Modifications to the BWR Emergency Procedure Guidelines to address Reactor Core Instabilities

The BWR Owners' Group Emergency Procedures Committee (EPC) has developed modifications to the BWR Emergency Procedure Guidelines (EPGs) [Reference 1] to address potential reactor core thermal-hydraulic instabilities, specifically large irregular power oscillations.

Figure 1. RPV Water Level Control Bands

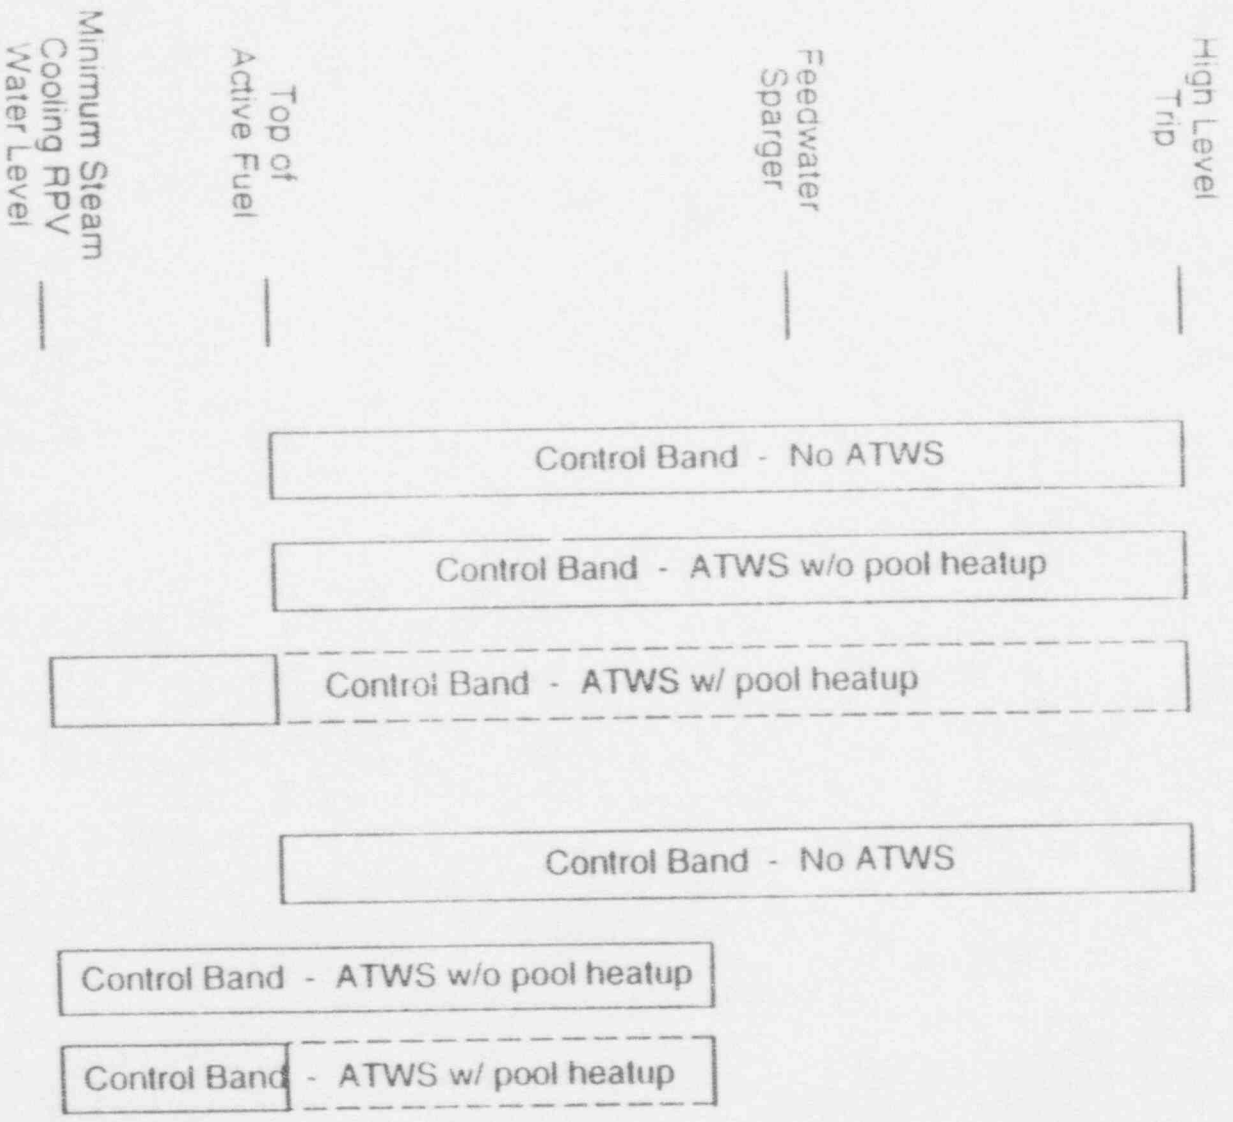
The RPV water level control bands employed in the current EPGs and those which will result from the EPG modifications to address potential reactor instabilities are illustrated in Figure 1.
